This addendum incorporates additional Wi-Fi and conduits to address the infrastructure for the RGB lighting system.

Pre-Bid ADDENDUM 2
(DSA ADDUNDUM 1)

Vista Murrieta High School

App# 04-125020
File # 33-H18

ENLARGED SITE PLAN

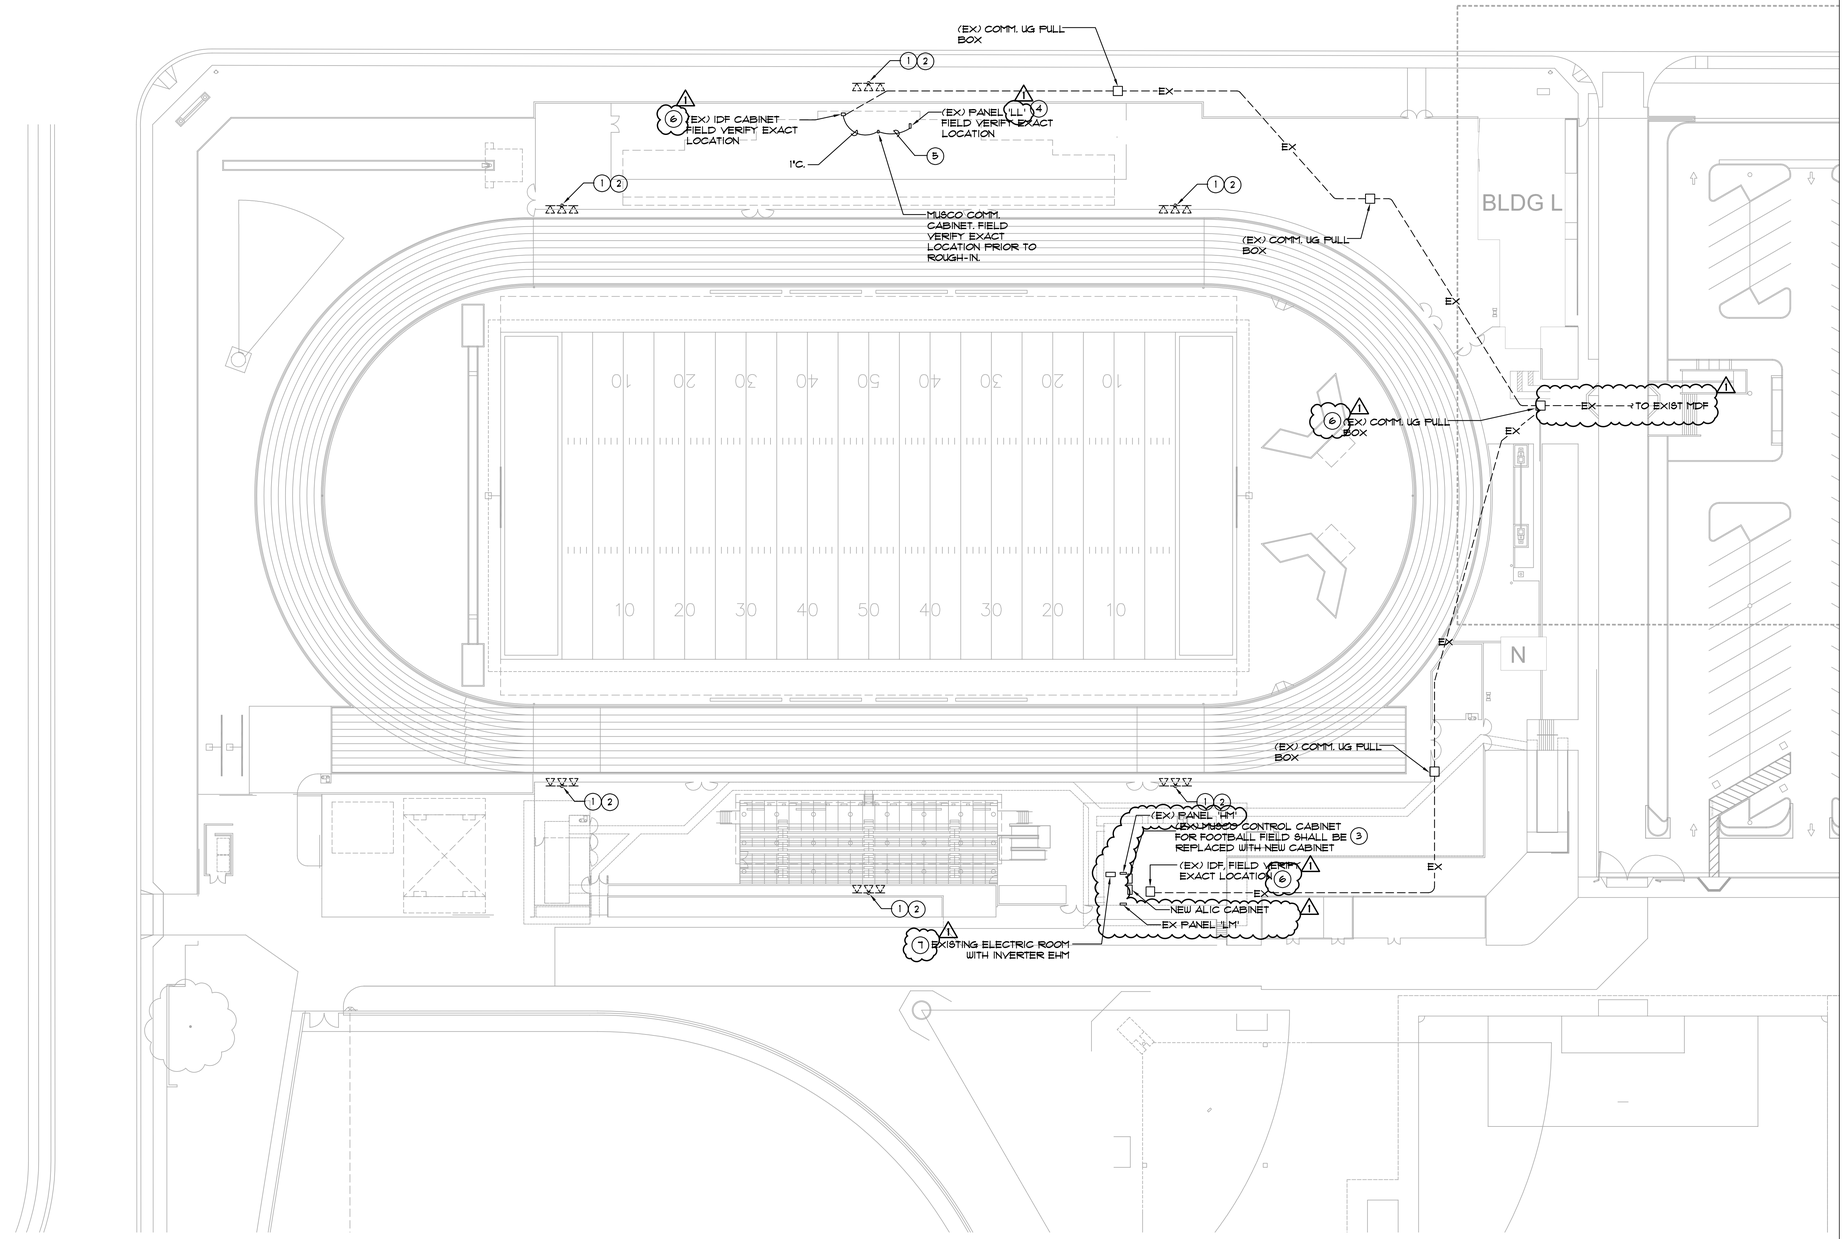
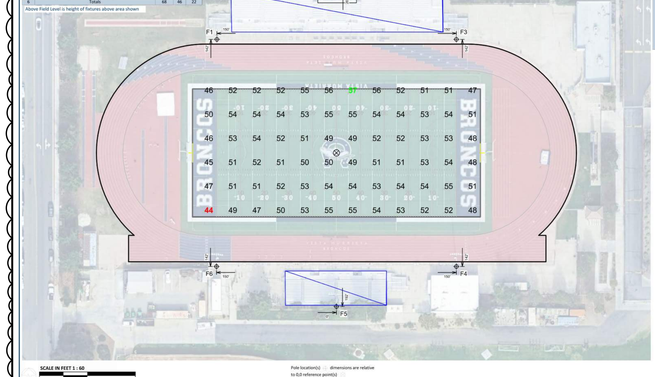
- **A.** Drawing E1.2 – ENLARGED SITE PLAN: Revised currently issued drawing per AD-E1.2
- **B.** Drawing E1.3 – FOOTBALL FIELD PHOTOMETRICS: Revised currently issued drawing per AD-E1.3
- **C.** Drawing E1.4 – FOOTBAL & SWIMMING POOL - PHOTOMETRIC: Revised currently issued drawing per AD-E1.2
- **D.** Drawing E7.1 – SPORT LIGHTING ONE LINE DIAGRAM: Revised currently issued drawing per AD-E7.1

4. PROVIDE (1) 20A/1P BREAKER IN EXISTING SPACE TO FEED MUSCO COMM. CABINET IN ANNOUNCER'S AREA.
5. 3/4"C. 2 #2, 1 #2 GND.
6. PULL BACK EXISTING FIBER CABLING FROM IDF CABINETS TO THIS PULL BOX. PULL NEW CONTROL CABLING ALONG WITH THE EXISTING FIBERS TO THE IDF ROOMS AND RECONNECT EXISTING FIBERS AT IDF LOCATIONS.

7. DEMOLISH EXISTING LIGHTING INVERTER AND REPLACE AS PER E1.1.

SPORTS LIGHTING ONE LINE DIAGRAM

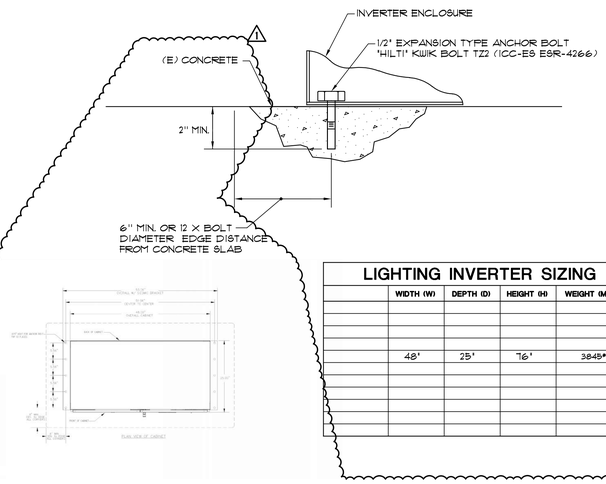
8. PROVIDE WIRING PER MANUFACTURER'S REQUIREMENTS.
9. REPLACE EXISTING BREAKER WITH 30A/1P.
10. PROVIDE NEW ALIC CABINET WITH (2) 1-1/4"C. BETWEEN LIGHTING INVERTER AND CABINET. PROVIDE 120V POWER CIRCUIT FROM PANEL 'LM' AND EMERGENCY POWER FROM LIGHTING INVERTER THROUGH 277V TO 120V TRANSFORMER.

11. DEMOLISH EXISTING CONDUCTORS IN EXISTING CONDUIT THE POLES. ROUTE NEW CONDUCTORS FROM ALIC THROUGH THE LIGHTING INVERTER AND IN EXISTING 1-1/4"C.
12. REPLACE EXISTING CIRCUIT BREAKER IN PANEL 'HM' FEEDING LIGHTING INVERTER WITH 10A/1P CIRCUIT BREAKER.
